LOST CREEK ISR, LLC

July 28, 2015

**Re: Reply to NRC's May 21, 2015 Letter Regarding License Condition 12.10
Lost Creek ISR Project License SUA-1598, Docket 040-09068, TAC J00717**

Figure 1
Lost Creek Plant Monitoring
for Compliance with 10CFR 40.65

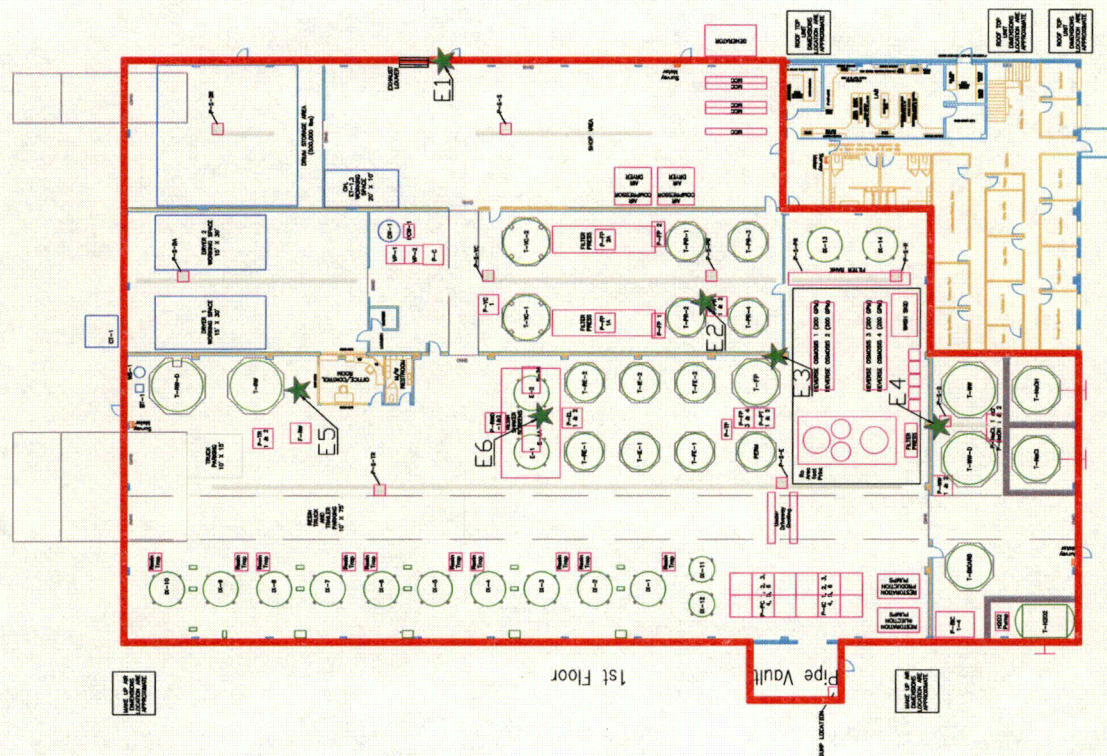
Question 4: Explain the significance of five boxed notes on Figure 1 which describe: (1) outside plant west wall at two location "Make Up Air Dimensions Locations Are Approximate," and (2) outside plant east wall at three locations. "Roof Top Unit Dimensions Locations Are Approximate."

Response 4: The 2 boxes labeled "Make Up Air Dimensions Locations Are Approximate" are the approximate locations of the fans supplying fresh air to the plant. The 3 boxes labeled "Roof Top Unit Dimensions Locations Are Approximate" represent the ventilation units for the offices.

FIGURE 3:

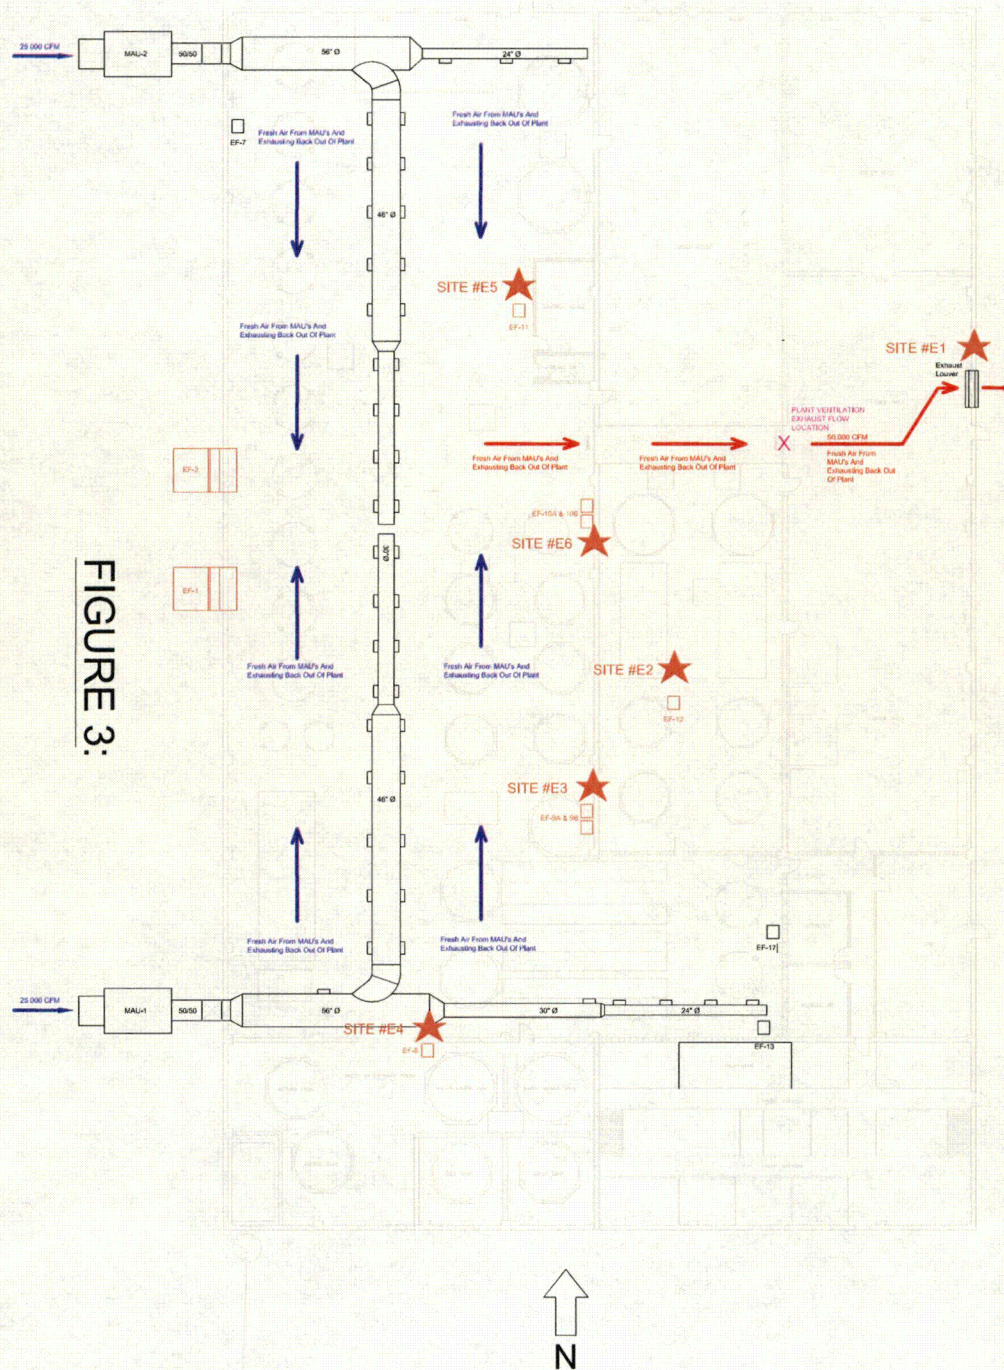
Question 2: Explain how LCI proposes to estimate the quantity of radionuclides released from other plant vents and rollup doors, including periods when rollup doors are open or closed.

Response 2: The fresh air supply into the plant is generated by two make-up air units that produce roughly 50,000 CFM total. During normal operations, the fresh airflow entering the plant is equal to the exhaust flow out of the plant. The average activity leaving the plant will remain unchanged with the doors open or closed; only the volume of air will change. Determining the airborne concentration while the doors are closed will result in a slightly conservative calculation of total radionuclides released. During normal plant operations, all external doors (man doors and bay doors) are closed. The exhaust louver, Site E1, Plant Wall Vent, on the east wall of the plant will always remain open to allow exhaust airflow from the building. The sampling related to License Condition 12.10 will be performed with all external doors closed. The airflow will be measured at "Plant Ventilation Exhaust

Flow Location" (Figure 3) in the bay doorway, using the Davis Instruments A/2 4 Vane Anemometer, or similar device.

Response 7: The sampling positions in the letter dated January 16, 2015 to the NRC in response to the RAI are the only sampling positions proposed to satisfy License Condition 12.10. The North Vent and South Vent locations corresponded to Site E1, Plant Wall Vent, in the January 16, 2015 letter to the NRC in response to an RAI regarding License Condition 12.10. The ventilation in the plant was changed per Safety and Environmental Review Panel (SERP LC15-01), dated January 22, 2015, to improve the ventilation through the whole plant. The North Vent and South Vent (EF-1 and EF-2 on Figure 3) locations are no longer being used as primary exhaust for the facility's main ventilation system, and remain off during normal operations. The fans EF-1 and EF-2 will only be used in the event of upset conditions. The Louvers in the plant Shop Area is the new locations for Site E1, Plant Wall Vent, because of the new flow path through the plant (see Figure 3).
